OAK HILL SUBDIVISION

APPLICATION NUMBER Holdover DATE July 20, 2006

DETAIL SITE PLAN

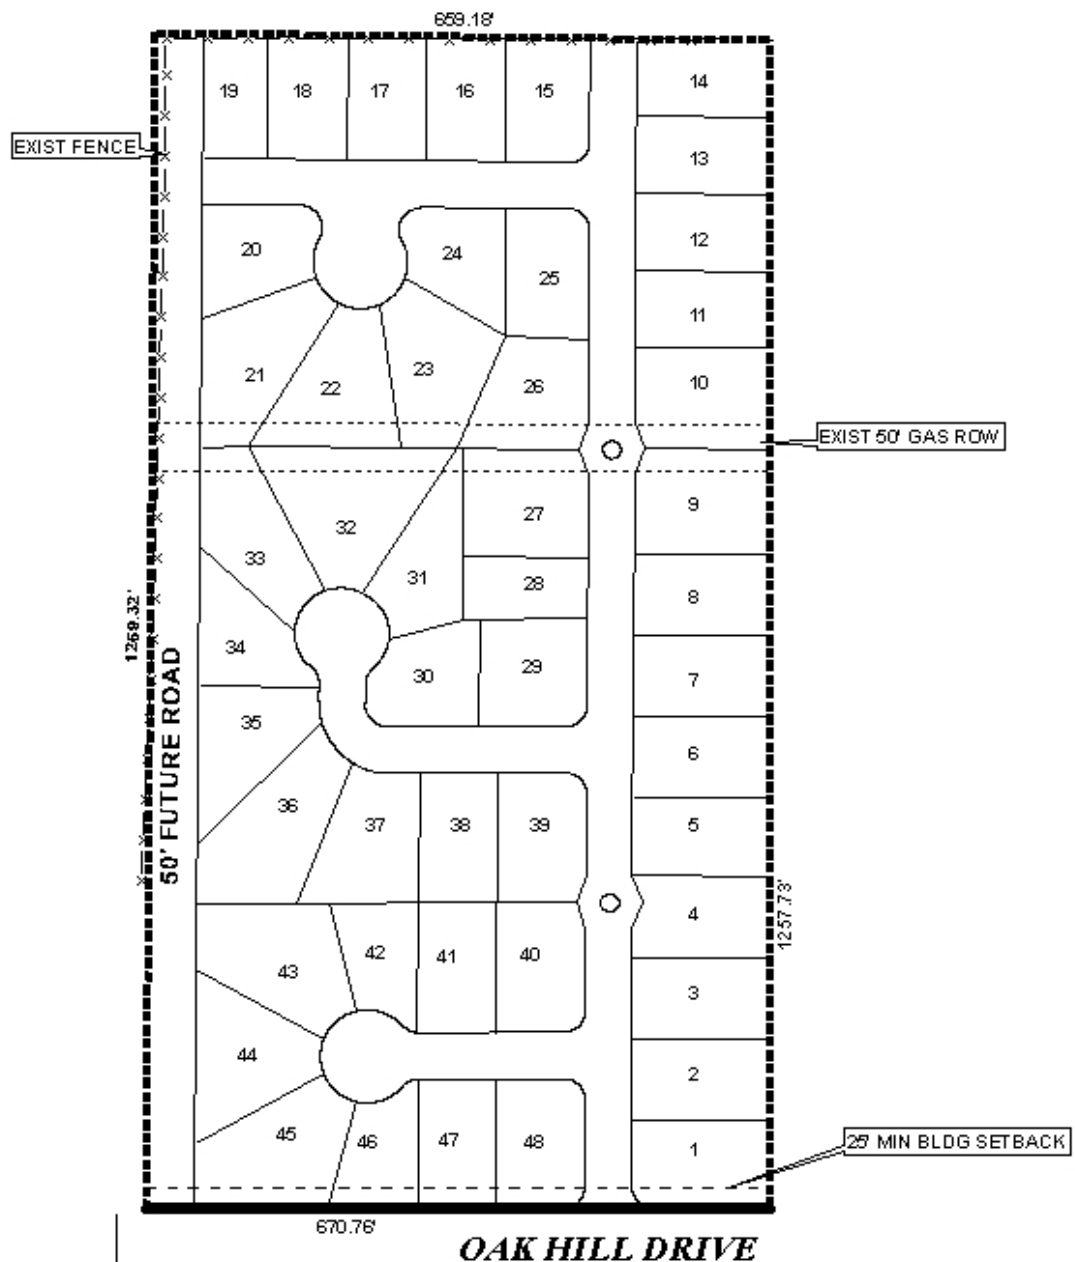
The site fronts Oak Hill Drive, with a 60-foot right-of-way; and adjoins (along the Western boundary) the future right-of-way of Magee Road, a planned major street requiring a 100-foot right-of-way. As such, dedication should be required to provide 50 feet from the centerline of the planned major street. It appears that the centerline of Magee Road may fall on (or very near) the Western boundary, in which case the proposed lots could be reduced by nearly half, and may not meet the minimum lot size requirements. The applicant should ensure that the design will provide for adequate area for all lots after dedication. In addition, as a means of access management, all lots should be denied direct access both to Oak Hill Drive and Magee Road.

The proposed subdivision also involves the creation of new streets, which must be constructed and dedicated to County Engineering standards prior to signing the final plat. One street is over 1200 feet long and very straight, and would therefore require calming devices; the only kind of calming device that the County will accept is a traffic circle. Based on its length, it is recommended that this street feature two traffic circles. Intersections might be suitable locations; however, size, location, and design will be subject to County Engineering approval.

Traffic circles should be shown on the final plat as common area. While detention is not shown on the final plat, if it is required, the space should be shown as “common detention area” on the final plat. A note should be required on the final plat stating that maintenance of all common areas is the property owners’ responsibility.

The 25-foot building setbacks are noted but not drawn; these should be drawn on the final plat.

This application was held over from the June 15th meeting to allow the applicant to revise drawings to show the planned major street dedication; adequate area for all lots; and traffic calming devices. The applicant has submitted a revised site plan illustrating all of the above. In addition, the site plan illustrates a street stub to the proposed major street, as would have been recommended; dedication of 25-foot curb radii at this intersection should also be required on the final plat.

Based on the preceding, the application is recommended for Tentative Approval, subject to the following conditions: 1) provision of proof that the site will have public water and sanitary sewer services, prior to signing the final plat; 2) depiction on the final plat of the major street right-of-way dedication for Magee Road, as shown on the plat submitted; 3) dedication of 25-foot curb radii at the intersection of the new street stub with Magee Road; 4) the placement of a note on the final plat stating that all lots are denied direct access both to Oak Hill Drive and Magee Road; 5) the labeling of all traffic circles as common area and the placement of a note on the final plat stating that maintenance of all common areas is the property owners' responsibility; 6) the construction and dedication of the new streets to County Engineering standards; 7) the placement of the 25-foot building setback lines on the final plat; and 8) the placement of a note on the final plat stating that any lots that are developed commercially and adjoin residentially developed property must provide a buffer, in compliance with Section V.A.7 of the Subdivision Regulations.
